# Technical Service Information

## THM 3L30 (180C) CONVERTER CLUTCH CHUGGLE/HUNTING

Figure 1

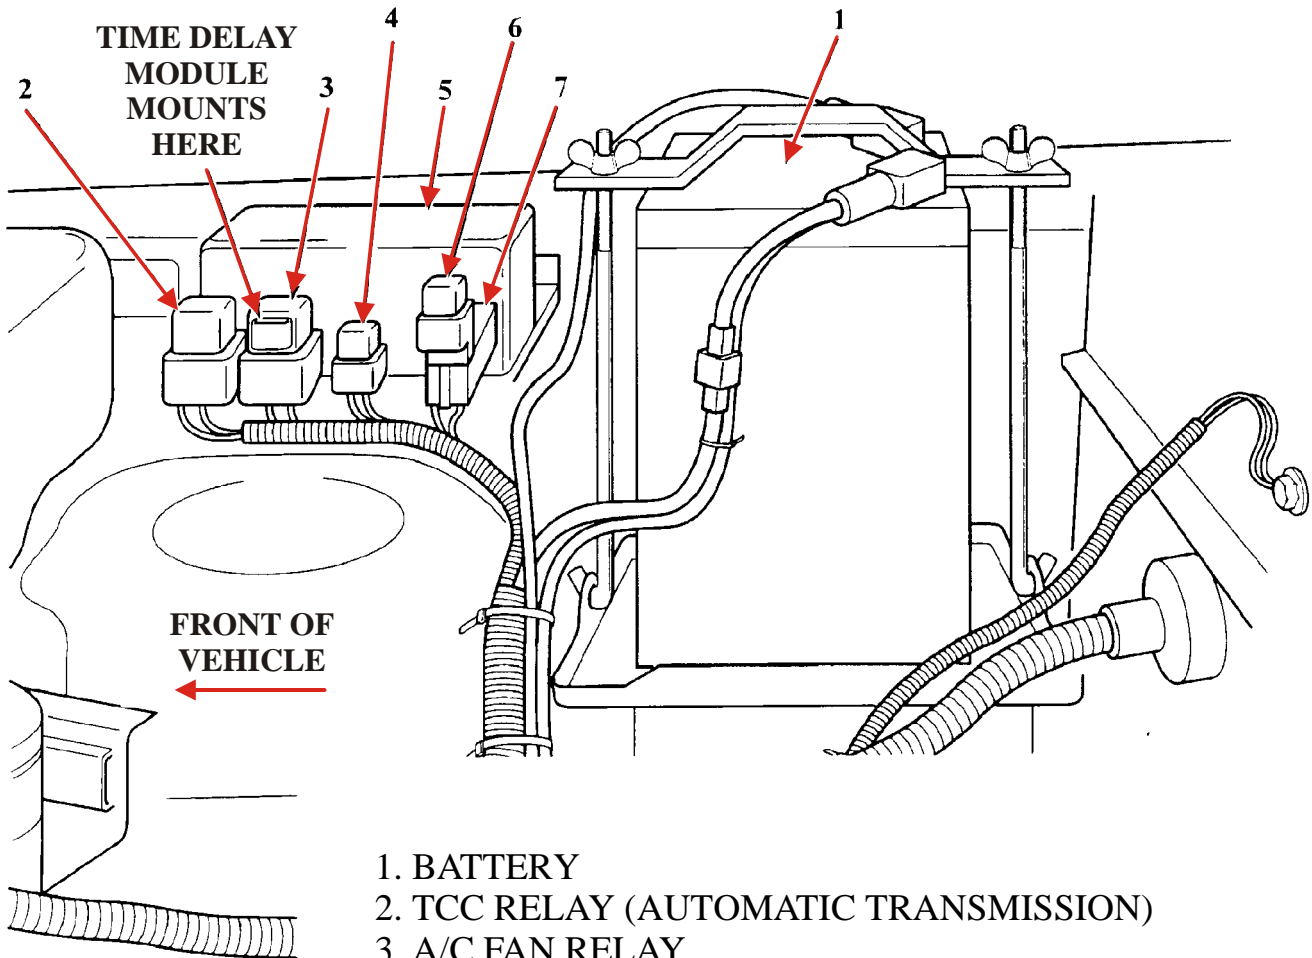
**COMPLAINT:** Some owners of 1989 thru 1995 model Geo Tracker, Cami Vitara, or Suzuki Sidekick, equipped with the THM 3L30 (180C) transmission, may experience a converter clutch “chuggle/hunting” condition. This condition occurs with the vehicle at normal operating temperature, in 3rd gear, at approximately 40-45 MPH on a level road or a slight uphill grade (noticed more on grade), the engine speed at 2500-2700 RPM, and the throttle opening at approximately 10 to 50 percent. Under these conditions, rapid, repeated apply and release of the converter clutch may cause a bucking or jerking sensation.

**CAUSE:** This condition may be due to Governor Pressure Switch instability when the vehicle speed is constant, and speed is at TCC apply speed.

**CORRECTION:** There is now available a new calibration update package, OEM part number 96040746, that should be installed. Use Figure 1 for proper assembly and identification. There is now available, under OEM part number 96041311, a Time Delay Module Kit that is installed into the TCC relay circuit to improve this condition.

1. Disconnect the battery (See Figure 1).
2. Remove the Green connector from the TCC Relay (See Figure 1).
3. Remove the White wire from the Green connector *carefully*, using a narrow blade screwdriver.
4. Install the White wire removed from the Green connector onto the Time Delay Module and wrap with electrical tape, as shown in Figure 2.
5. Install the Red wire from the Time Delay Module into the cavity of the Green connector where the White wire was removed (See Figure 3), and reconnect the Green connector to the TCC relay.
6. Clip the Time Delay Module onto the A/C Fan Relay (See Figure 1).

Figure 2

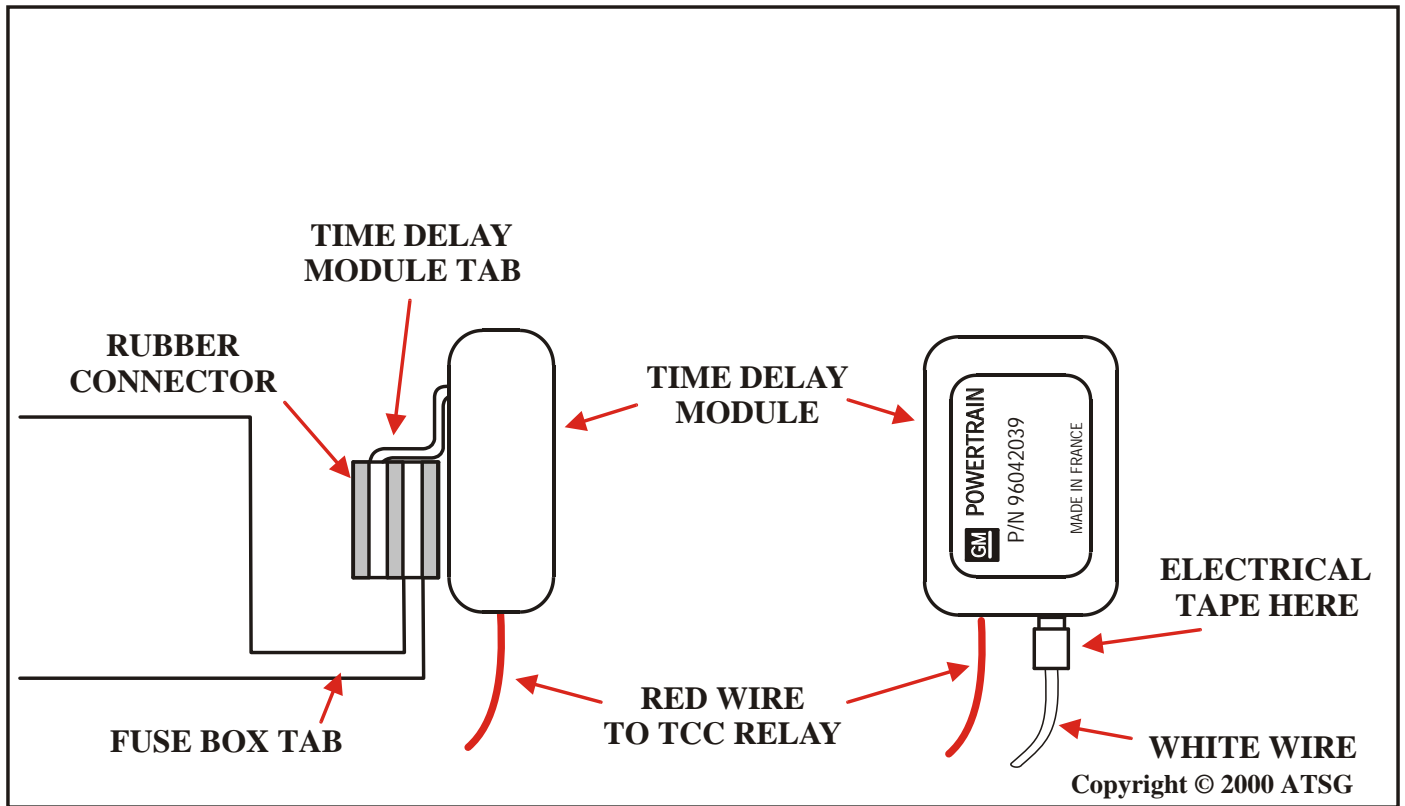
*Note: If the vehicle is not equipped with air conditioning, install the rubber connector included in the kit, onto the fuse box tab and then clip the Time Delay Module onto the rubber connector, as shown in Figure 2.*
